Access Compliance Report

Public Rights-of-Way

(Curb Ramps)

Intersection ID: 49184	Main Street: ST_GERMAINE_LN	Cross Street: ST_STEPHEN_LN	Location: SW
ADA ID: 5A216B127E84	Ramp Type: Perp	Initial Pass/Fail: Fail	Overall Compliance: No
Severity Score: 13.75			
Codes/Mitigation Info/Possible Solution		Field Measurements/Component Compliance

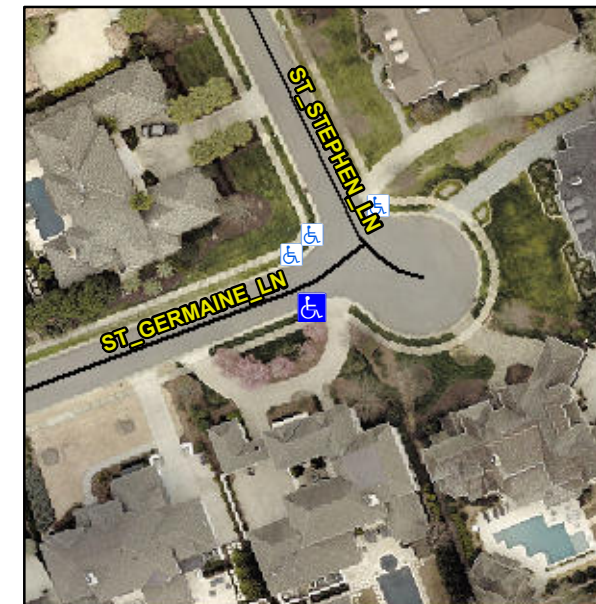
Not Found, R304.2.2

Compliance	Description	Data	Compliance	Description	Data
N/A	Ramp Length (in)	50.5	No	Ramp Slope (%)	11.1
Yes	Ramp Width (in)	48.0	Yes	Ramp XSlope (%)	3.8
N/A	Flare Type LT	N/A	N/A	Flare Type RT	N/A
N/A	Flare Slope LT (%)	N/A	N/A	Flare Slope RT (%)	N/A
N/A	Flare Traversable LT?	N/A	N/A	Flare Traversable RT?	N/A
N/A	Landing Length (in)	N/A	N/A	DWS Provided?	N/A
N/A	Landing Width (in)	N/A	N/A	DWS Contrast?	N/A
N/A	Landing Slope (%)	N/A	N/A	DWS Length (in)	N/A
N/A	Landing X Slope (%)	N/A	N/A	DWS Full Width?	N/A
N/A	Landing Curb? (Y/N)	N/A	N/A	DWS Offset (in)	N/A
N/A	Shared Landing?	N/A			
N/A	Gutter Ponding?	N/A	N/A	Gutter Slope (%)	N/A
N/A	Gutter Lip Ht (in)	N/A	N/A	Gutter X Slope (%)	N/A
N/A	Painted X Walk1?	No	N/A	Painted X Walk2?	N/A
	X Walk 1 Direction	To N		X Walk 2 Direction	N/A
N/A	X Walk 1 Width (in)	N/A	N/A	X Walk 2 Width (in)	N/A
	X Walk 1 Slope (%)	3.0		X Walk 2 Slope (%)	N/A
	X Walk 1 X Slope (%)	5.9		X Walk 2 X Slope (%)	N/A

Remove & Replace Entire Ramp.
